From: YC Lit <[REDACTED]>
Sent: 19 January 2026 18:33
To: tpbpd/PLAND
Cc: [REDACTED]
Subject: Re: Planning Application Lot 1229 (Part) & 1367 RP (part) in DD 106 A/YL-KTS/1108S
Attachments: Responses-to Comments. from various Govt. Dept Lot 1229,1367 RP in DD 106.pdf; Drainage Proposal Lot 1229 Figure D01 new.pdf KTS1108.pdf; Figure 01 Re, F Lot 1229 in DD 106 KTS 1108.pdf; Table 1 KTS 1108_0001.pdf; S.16 Form P.5 & 11 KTS 1108_0001_0001.pdf; P.6 & 7 of Plannning Statement KTS 1108_0001_0001_0001.pdf
Categories: Internet Email

Response-to-the Departmental Comments

Proposed Temporary Warehouse (excluding Dangerous Goods Godown) with Ancillary Facilities and Associated Filling of Land for a Period of 3 Years at Lot Nos. 1229 (Part) and 1367(Part) in DD 106, Kam Tin South, Yuen Long, N.T. (Application No. A/YL-KTS/1108)

Figure:
D-01
Scale:
1 : 500
Date:
Jan., 2026

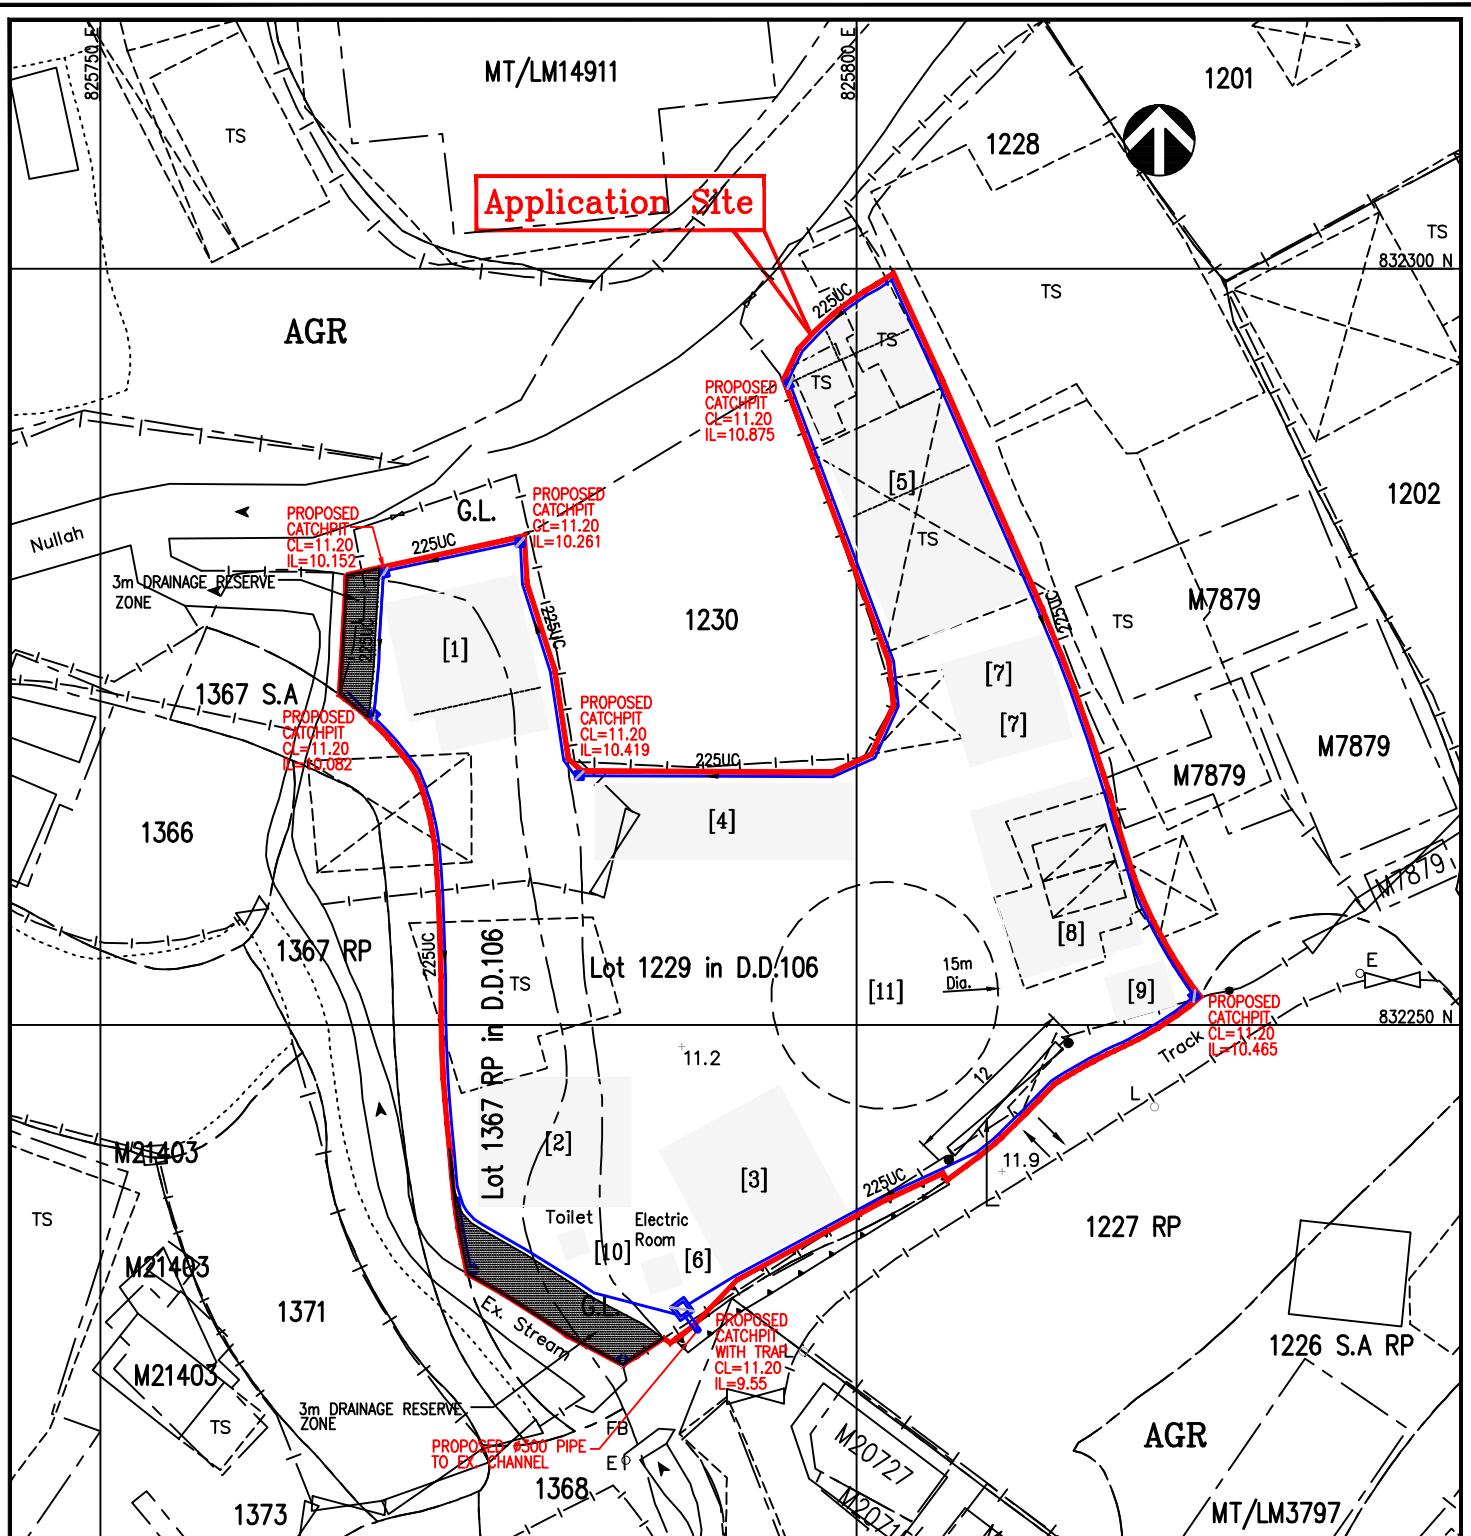
<p>The applicant shall also be required to place all the proposed works 3m away from the top of the bank of the streamcourse/channel. All the proposed works in the vicinity of the streamcourse/channcl should not create any adverse drainage impacts, both during and after construction.</p>	<p>Noted. All proposed works is now 3m away from the top bank of the streamcoursze/channel. The applicant will take extreme care when carrying out the proposed works and make sure that all proposed would not create any adverse drainage impacts, both during and after construction.</p>
<p><u>Response to Agriculture, Fisheries and Conservation Department (AFCD)'s Comments</u></p>	
<p>There is a watercourse located to the west of</p>	<p>Noted.</p>

<p>they will be approved. The STW and STT, if approved, will be subject to such terms and conditions including the payment of waiver fee, rent and administrative fee as considered appropriate by LandsD. Besides, given the proposed use is temporary in nature, only erection of temporary structure(s) will be considered</p>	<p>appropriate by LandsD.</p>
<p><u>Response to Drainage Services Department (DSD)'s Comments</u></p>	
<p>We are unable to provide comment on drainage aspect of the application at this stage. Comment on drainage aspect will be provided when the drainage proposal as mentioned in section 4.5 of the planning statement is received.</p>	<p>Noted. Drainage Proposal which had included the comments from DSD (Drainage Layout Plan (Figure D-01) is hereby submitted for DSD 's consideration.</p>
<p>In addition, the proposed development site is close/adjacent to the existing streamcourse/channel. There is a potential increase flooding risk to the area if the stream is disturbed or affected by the operation of the applicant. Therefore, I would recommend the application site to exclude the streamcourse/channel and the adjoining areas 3m from the crest of the streamcourse/channel. from the captioned S.16 application.</p>	<p>Noted. 3 m drainage reserve will be imposed at the application site.</p>
